SUBJECT DP-90 - TY-CEN Community Unit Plan

**Re: S/D 79-14 - Ty-Cen Addition, Final plat**

Re: S/D 79-14 - Preliminary plat of Ty-Cen Addition

Subject Drainage Calculations

Typical Channel Section

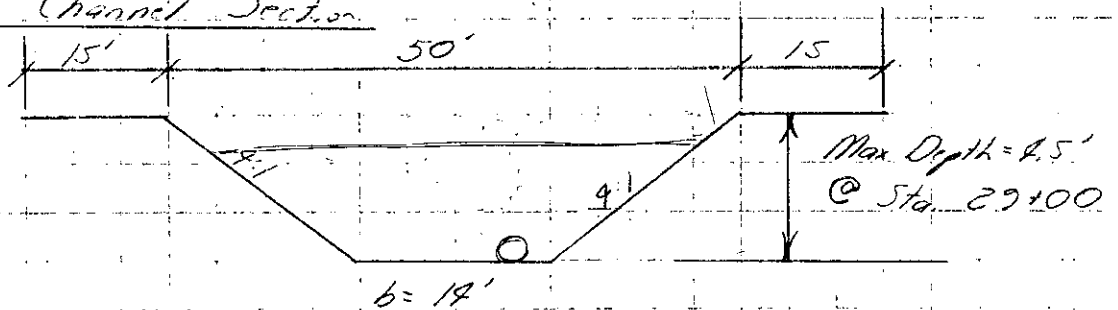
East Channel:  $b = 14'$   $ss = 4:1$  length = 1260'  
 South Channel:  $b = 14'$   $ss = 4:1$  length = 1260'

Ave Depth East Channel = 2.75'

Ave Depth South Channel = 3.25'

Channel Section: East =  $(2.75)(14) + 2.75(4)(2.75) = 68.75 \text{ ft}^2/\text{ft}$

South =  $(3.25)(14) + 3.25(4)(3.25) = 87.75 \text{ ft}^2/\text{ft}$

$$\text{Total Volume} = [1260(68.75) + 1260(87.75)] / 43560$$

$$= 4.53 \text{ Ac ft}$$

$$\text{On Site Storage} = 7.18 - 4.53 = 2.65 \text{ Ac ft}$$
